# **Roe Highway Extension**

Addendum to Wetlands
Monitoring and
Management Plan

# Roe Highway Extension - Addendum to WMMP

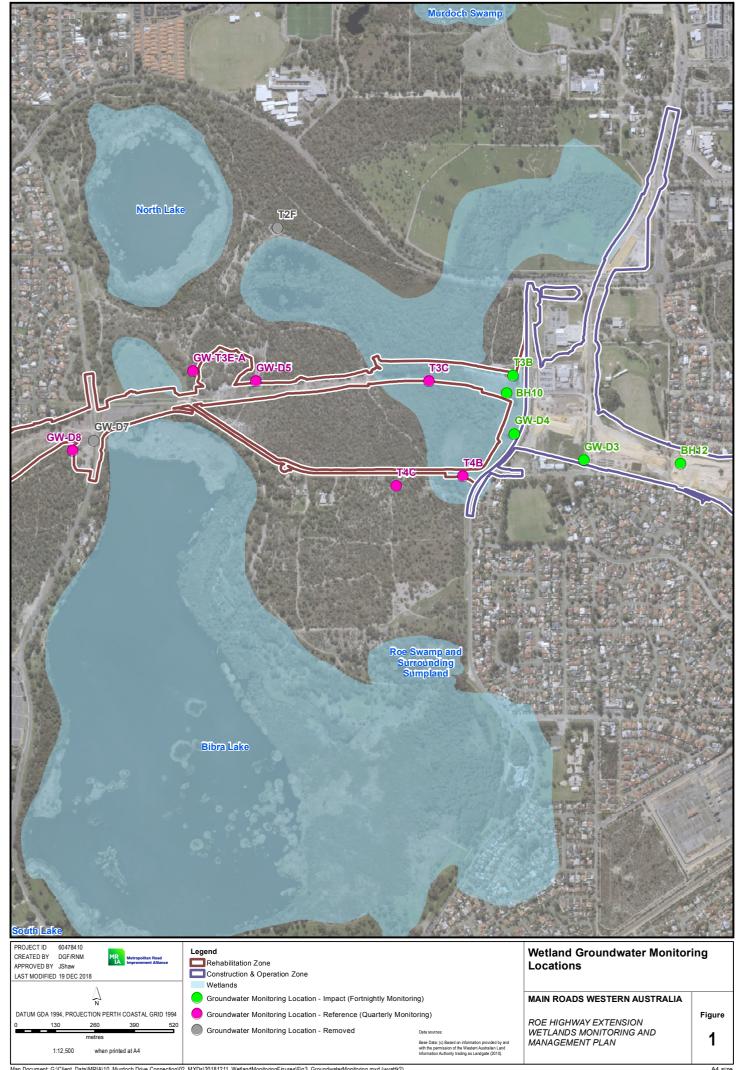
Given the area of active construction has changed, the assignment of 'impact' and 'reference' should be adjusted. Additionally, there are two bores that are inaccessible and will need to be removed from the program. These changes are shown in Figure 1.

This addendum amends the assignment of 'impact' and 'reference' for groundwater bores, as shown in Table 2:

Monitoring	Type listed	Changes to WMMP				
Bore	WMMP	Updated	Justification			
GW-T2F	Impact		GW-T2F and GW-D7 have been permanently destroyed.			
GW-D7	Impact	Remove from WMMP	Re-drilling is not necessary as they are not located near construction activities. Surrounding bores should be sufficient for the monitoring programGW-T2F and GW-D7 have been permanently destroyed. Redrilling is not necessary as they are not located near construction activities. Surrounding bores should be sufficient for the monitoring program			
GW-T3B	Impact		These bores are within the active construction area and should be			
BH10	Impact	1.54	considered 'impact' bores.			
BH12	Reference	List as impact				
GW-D3	W-D3 Impact					
GW-D4	Impact					
GW-T3C	Impact		These monitoring bores are located to the west of Bibra Drive, where			
GW-T4B	Reference		active construction will not occur.			
GW-T4C	Reference	List as	Further fortnightly sampling at these locations provides no

GW-D5	Impact	reference	environmental benefit to protecting the wetlands or water quality.			
GW-D8	Impact	]				
GW-T3E-A	Impact

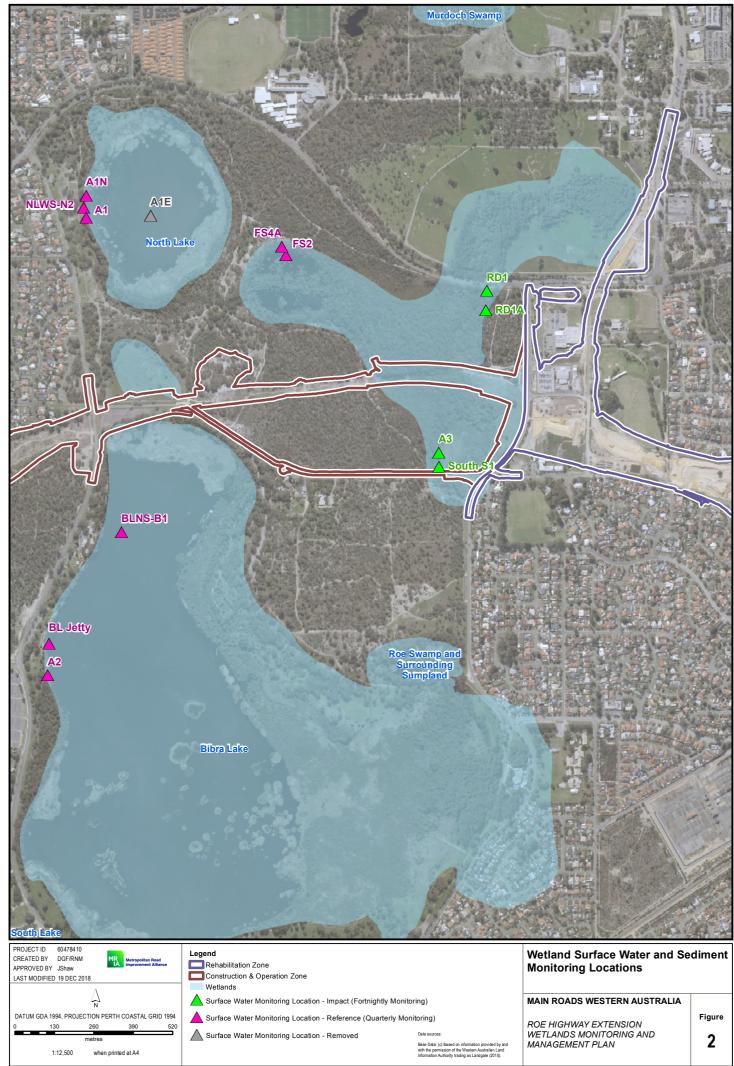
#### This addendum removes monitoring location A1E from the WMMP, due to:

A1E is the only surface water location that is inaccessible. This monitoring location is in the centre of the North Lake wetland and is either not sampled or the location is altered due to health and safety reasons. Given there are three other monitoring locations at North Lake, A1E is not necessary for monitoring potential impacts and should be removed from the program. Surface water monitoring locations are displayed in Figure 2.
